Memorandum

Date: June 21, 2006

Subject: Application of the WHR Habitat Classification Model and Non-Industrial Management Plan 1-06NTMP-012 SCL

Figure 1. Portion of NTMP area and areas visited during February 7th, 2006 preconsultation.

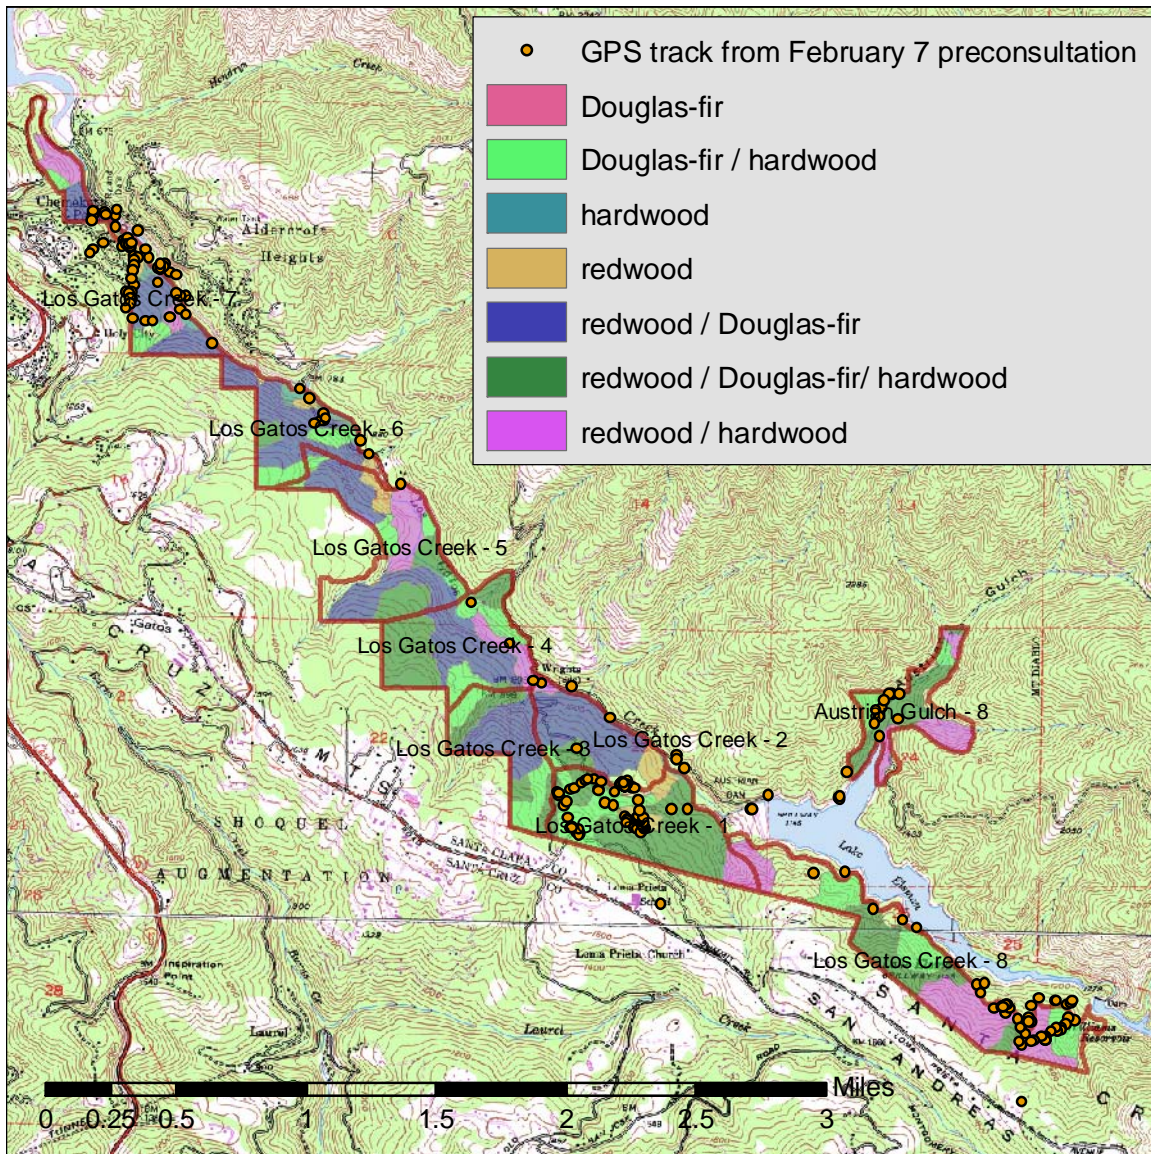
During the pre-consultation, DFG scientists walked through several different stands. The entire plan area was not completely covered. Some stands appeared to have more than one distinct canopy layer. These included Douglas-fir and Douglas-fir/hardwood stands at the south end of the plan area in Unit 8; and Douglas-fir, redwood, and redwood / Douglas-fir / hardwood stands in and around Unit 1.
